OICA PROPOSAL FOR DRAFT AMENDMENTS TO REGULATION No. 83

PROPOSAL

Fig. 1: Development of engine cool down times.

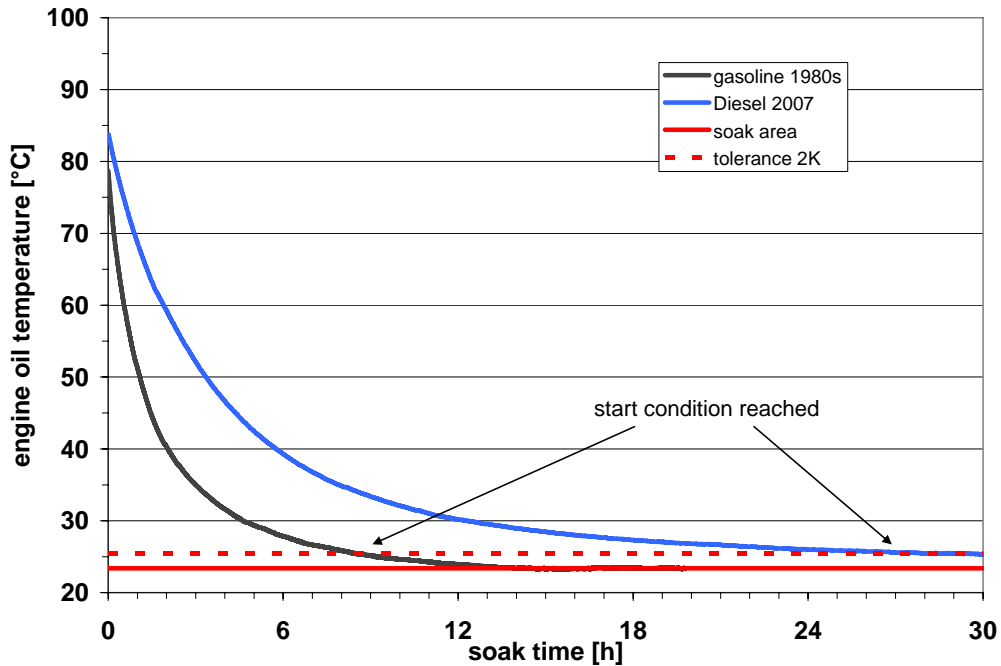
Actual vehicle/engine concepts use encapsulation measures to reduce external noise and aerodynamic drag. As a side effect this leads to extended cool down times of the power train after engine shutoff. Fig. 1 shows the impact of these developments to the engine cool down times.

Contrary to the development of noise reduction and aerodynamic measures leading to longer cool down times, the preconditioning requirement of test Type I remained unchanged. The regulation defines a minimum soak period of 6 hours and a start condition of engine oil and coolant temperature in between $\pm 2^{\circ}\text{C}$ of the temperature of the soak area ($20\text{-}30^{\circ}\text{C}$), before the emission test can be started. Modern vehicle concepts remain in a warmed up condition with engine temperatures above 2 K above ambient temperature for more than 24 hours. This situation causes increased workload in the development and type approval process as additional cooling fans have to be used to reduce the soak times between preconditioning cycle and emission test (forced cooling down).

As an alternative, after this preconditioning, the vehicle shall be kept in a room in which the temperature remains relatively constant between 293 and 303 K (20 and 30°C) for not less than 12 hours nor for more than 36 hours prior to the exhaust emission test.

As an alternative, after this preconditioning, the vehicle shall be kept in a room in which the temperature remains relatively constant between 293 and 303 K (20 and 30 °C) for not less than 12 hours nor for more than 36 hours prior to the exhaust emission test.
